Android Indoor Station Firmware Release Note

V2.1.80_build230320 (2023-04-14)

Firmware Basic Information	Firmware Version	V2.1.80_build230320
	Device Model	DS-KH9310-WTE1(B) DS-KH9510-WTE1(B)

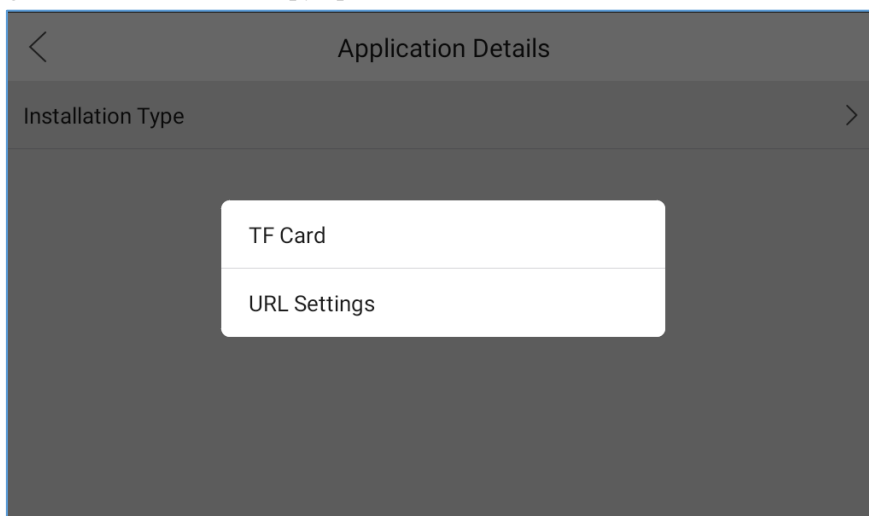
1. Support 16 indoor extensions.
2. Support 5 apps maximum (was 2 in previous version), total storage \leq 1 GB, RAM \leq 500 MB, CPU \leq 30%

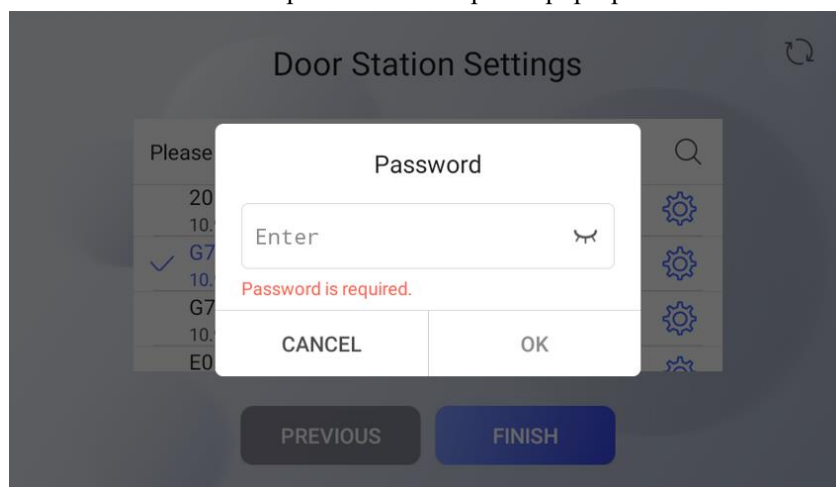
2. Add new function in wizard to check whether the activation password of the door and indoor station are the same, if not, it will prompt to enter the door station password in a separate pop-up box.

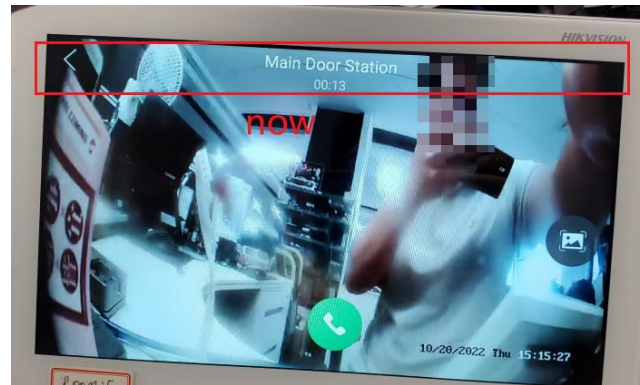
1. Change the gradient background at the top of the preview screen to transparent

Live View

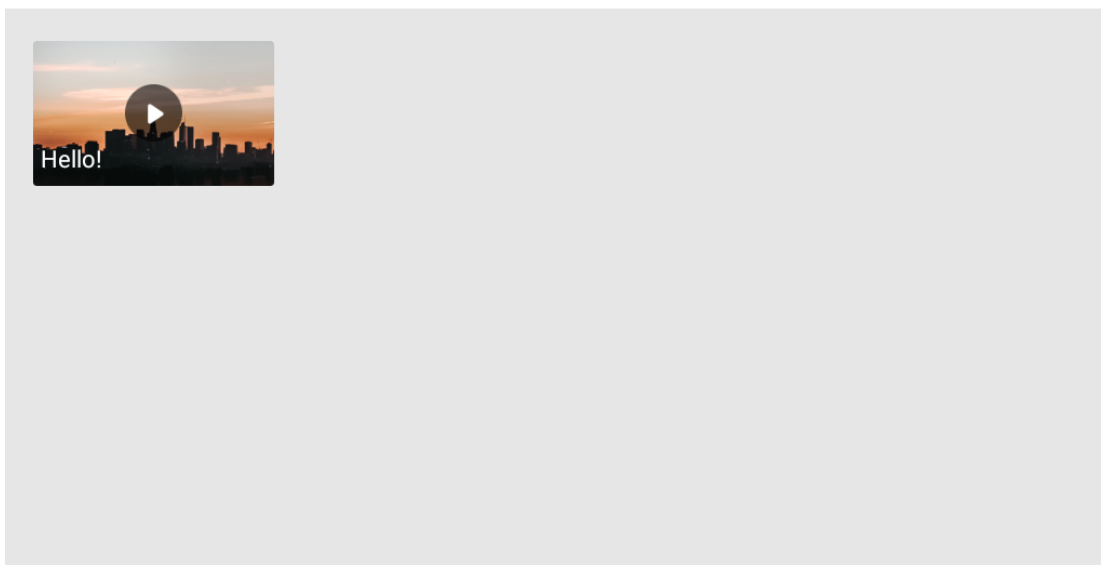
1. Extends the limited third-party resource. (Memory 500 M CPU 30% flush 1G)
2. Displays custom device name on the live view list and the corresponding live view website page.

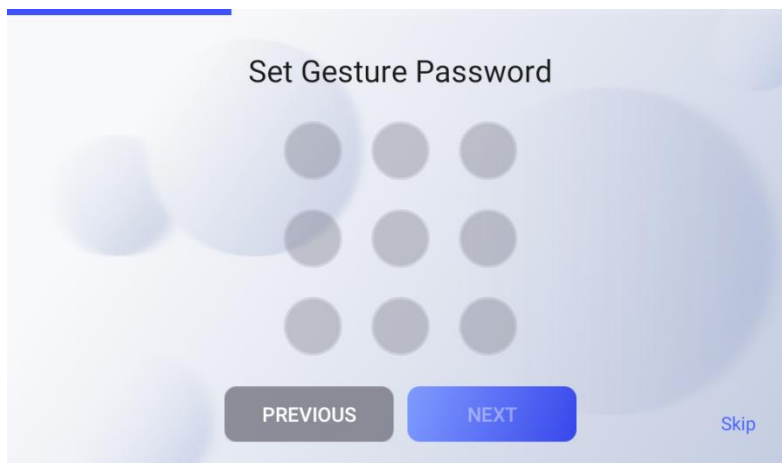
1) Support reset admin password via email or security questions.

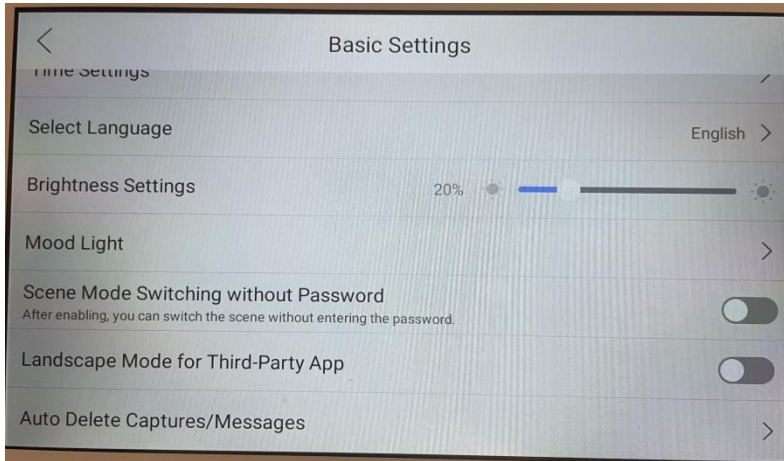
2) Support unlock via gesture.

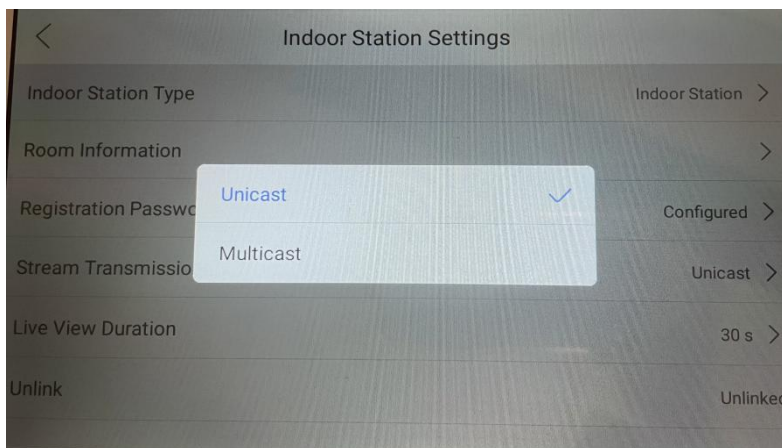
1) Support unicast and multicast options for video stream.

For multicast mode, the new version is supported up to 15 channels of video stream, but the switch or router must support the multicast mode at the same time, otherwise it can only support 6 channels of video stream.
